**30-045-25630 LOCKE SWD #001**

DUGAN PRODUCTION CORP

Re: Permanent Abandonment  
Well: Locke SWD

**BLM FLUID MINERALS  
Geologic Report**

Locke # 1 SWD  
Current Wellbore Schematic  
30-045-25630  
P, Sec 3 T29N & R 14W  
1120' FSL & 1120' FEL

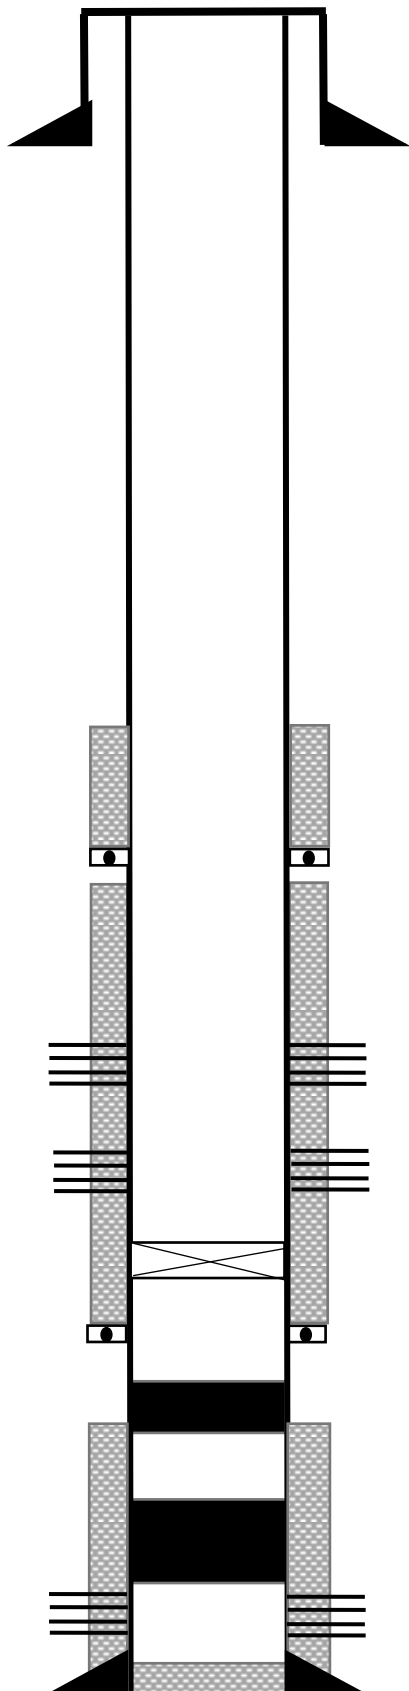
1. Plugging operations authorized are subject to the attached "General Requirements for Permanent Abandonment of Wells on Federal and Indian Lease."
2. Farmington Office is to be notified at least 24 hours before the plugging operations commence (505) 564-7750.
3. BLM picks top of Cliffhouse at 2540. See attached geologic report. Ensure coverage of Fruitland top 2490-2490.

- Please ensure that the top of the Pictured Cliffs is isolated by proper placement of cement plugs. This will protect the freshwater sands in this well bore.

- Please note that the BLM geologist's picks for the Fruitland and the Chacra vary significantly from the operator's picks.
